**CITY OF KIRKLAND**  
**Planning and Community Development Department**  
**123 Fifth Avenue, Kirkland, WA 98033**  
**425.587-3225 - [www.kirklandwa.gov](http://www.kirklandwa.gov)**

**MEMORANDUM**

**Subject:** ADOPTION OF ORDINANCES AND SUMMARY ORDINANCES AMENDING THE KIRKLAND ZONING CODE, MUNICIPAL CODE, AND PLANNED ACTION ORDINANCE FOR THE PARKPLACE AMENDMENT REQUESTS (FILE NO. CAM14-02188)

Special setbacks at southern portion of site.

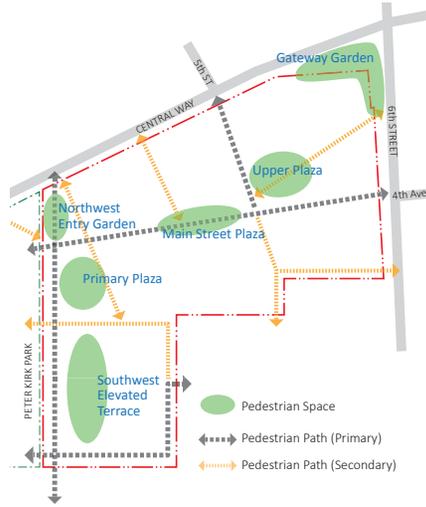
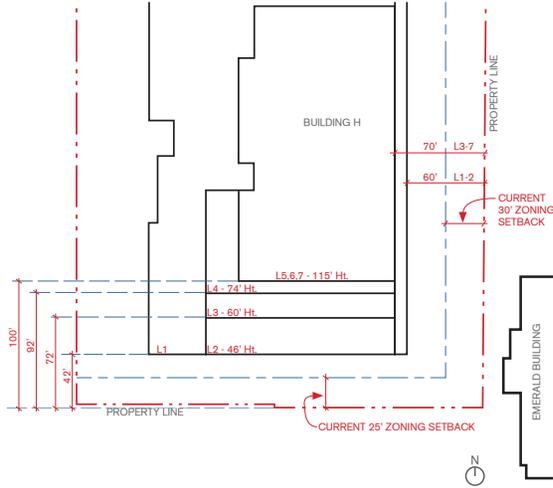
- Additional setback and height requirements for buildings located in the southern portion of the site (see page 12 of the Master Plan and Design Guidelines). This change is in response to a request by Ken Davidson, the owner of an office building to the east of the site. Mr. Davidson and the developers have come to an agreement regarding the project, and he now supports their proposal.

1 Central Way Frontage Section (typical)

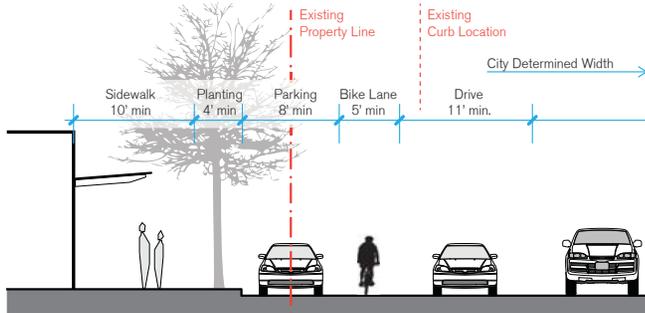
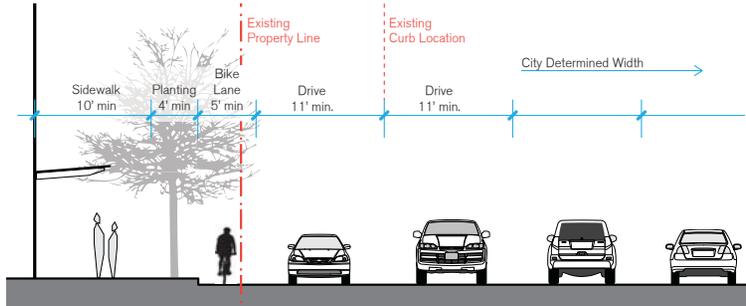
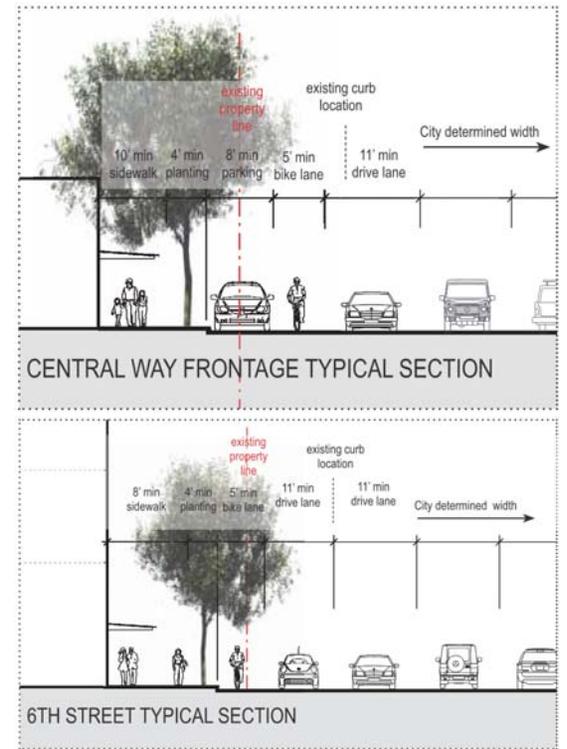
- Some minor reconfigurations of street sections (e.g., sidewalks, parking lanes) on some streets, although sidewalks are generally the same or wider.
- A change in the primary site access to Central Way at 5<sup>th</sup> Ave.;
